INFOTECH 22-11b

SUPPORT DE RACLEUR

INFOTECH22-11b

MUD SCRAPER BRACKET

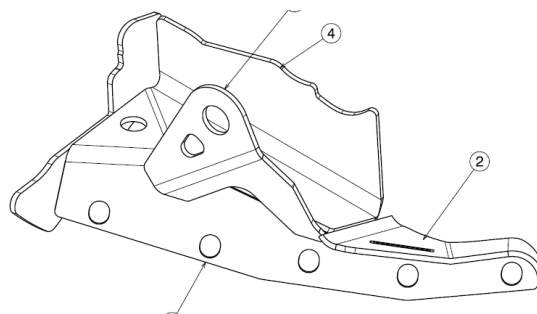
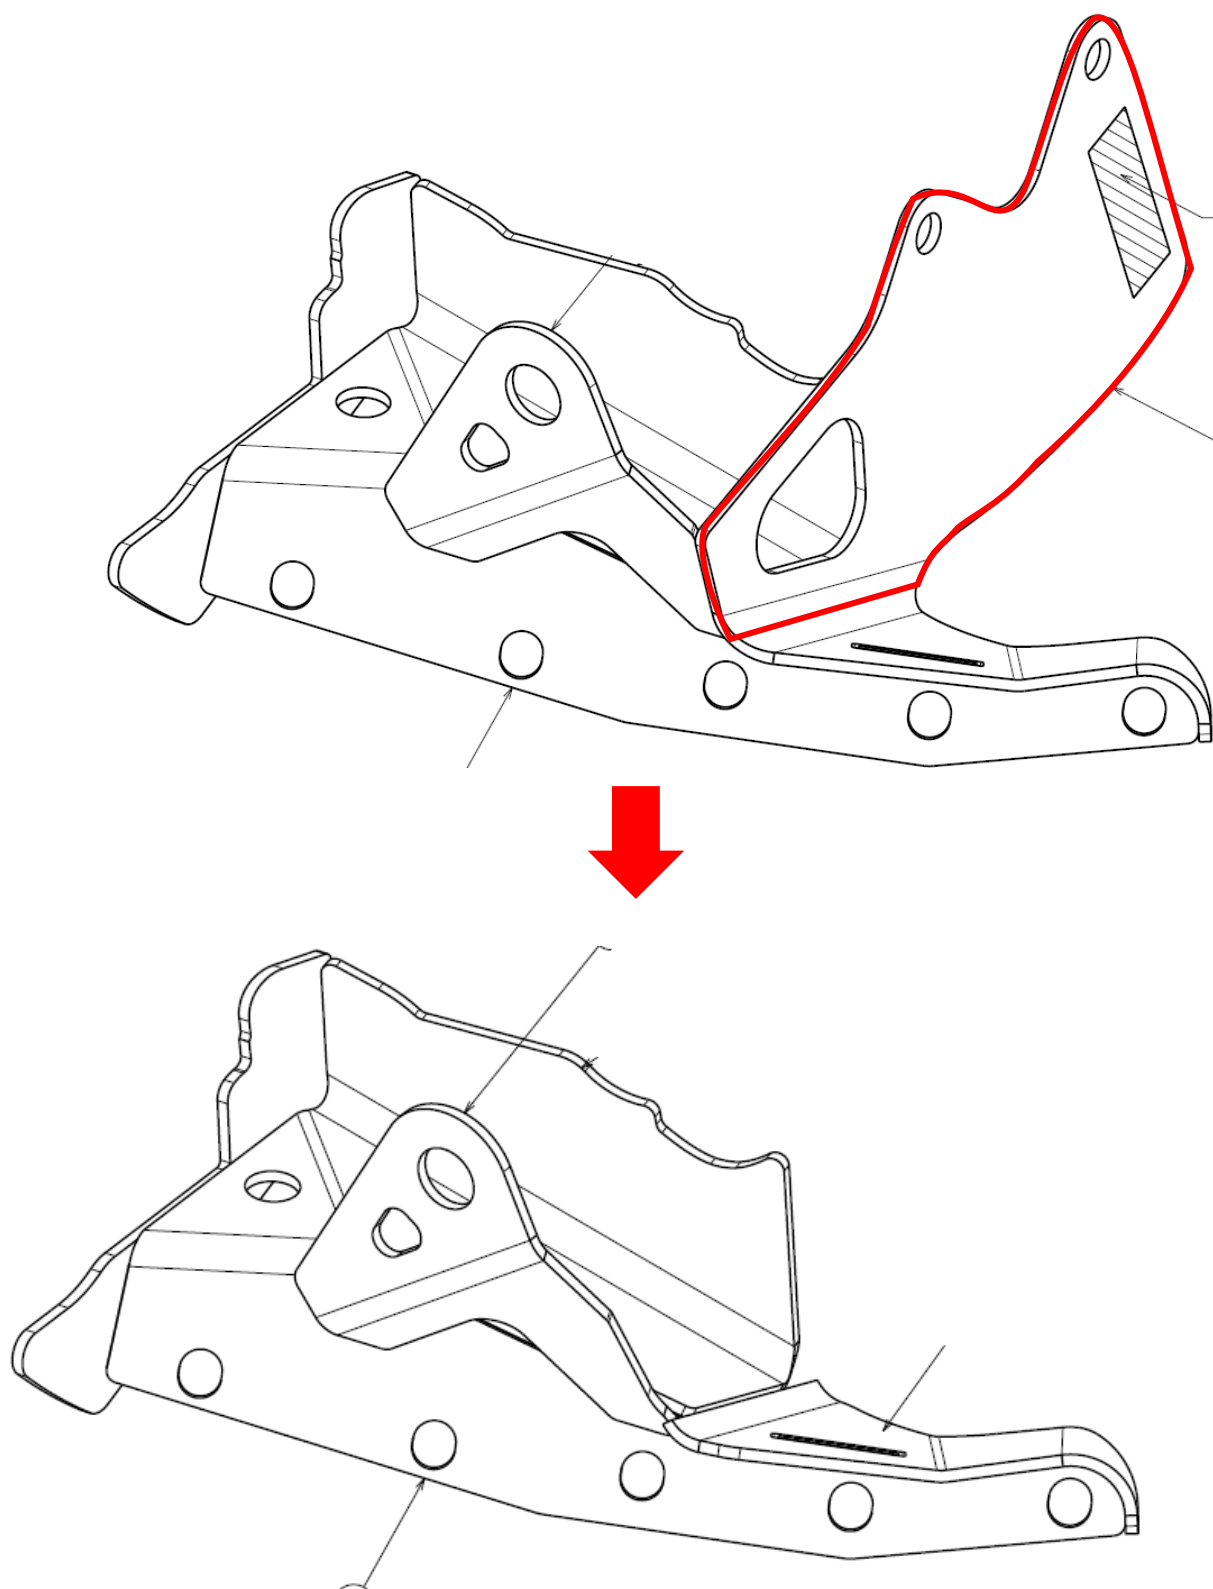
Une nouvelle version du support de racleur, compatible avec les nouveaux disques de frein terre (ep 33mm) sera bientôt disponible auprès de RacingShop :

Vous pouvez également modifier vos supports actuels (ref 904487528E pour le support D et 904487538E pour le support G) en supprimant la tôle de protection de point D comme ci-dessous.

Partie à supprimer :

Support de racleur G : 904904378B

Support de racleur D : 904904388B

Ce nouveau racleur sera homologué à partir du 1^{er} mars 2023.

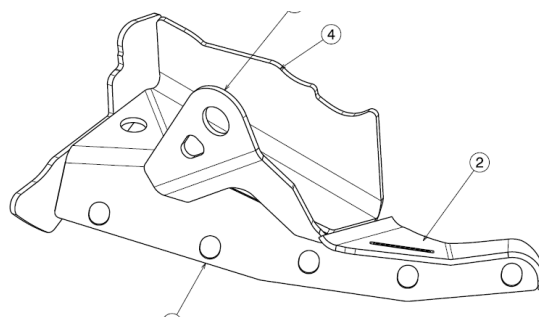
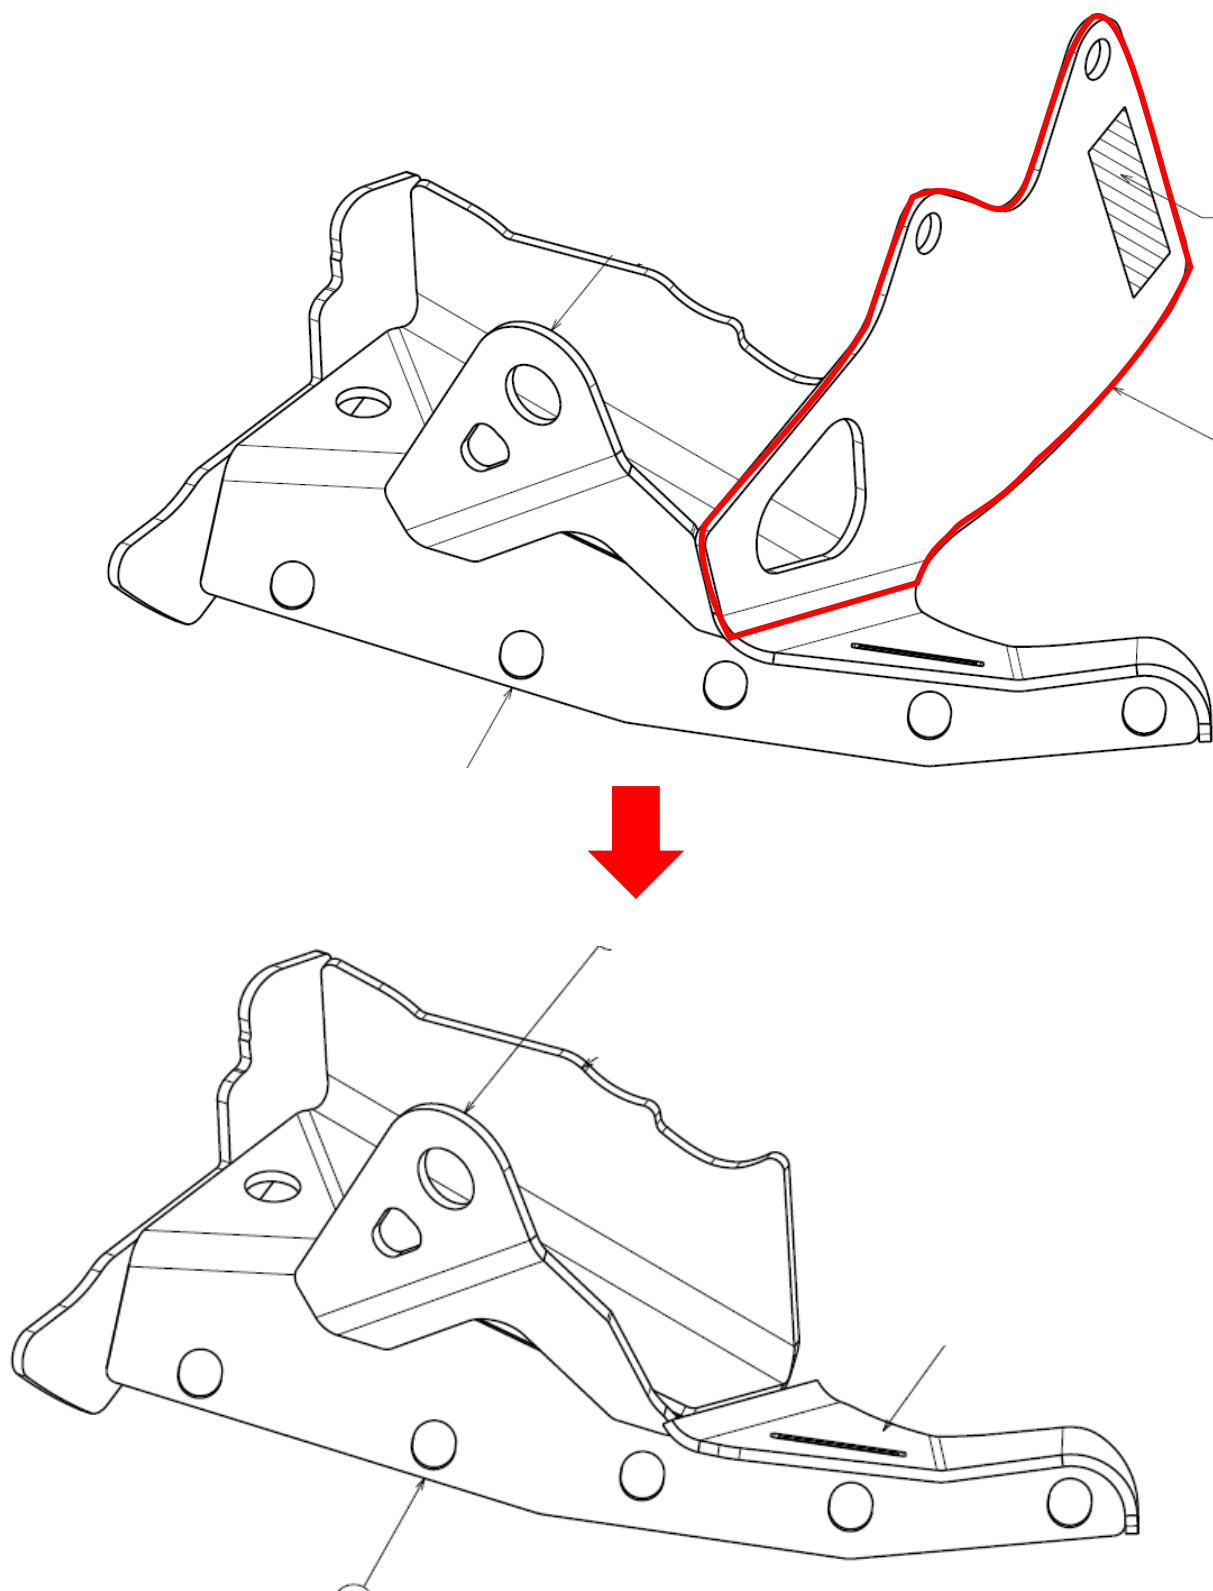
An update of the mud scraper bracket, to suit the new gravel brake discs (33mm thick), will be available soon at RacingShop:

Meantime, you can also modify your current brackets (ref 904487528E for left one and 904487538E for the right one) by removing the point D protection as follow:

Area to be removed :

Left mud scraper bracket: 904904378B

Right mud scraper bracket: 904904388B

This new mud scraper bracket will be homologated from 01/03/2022.
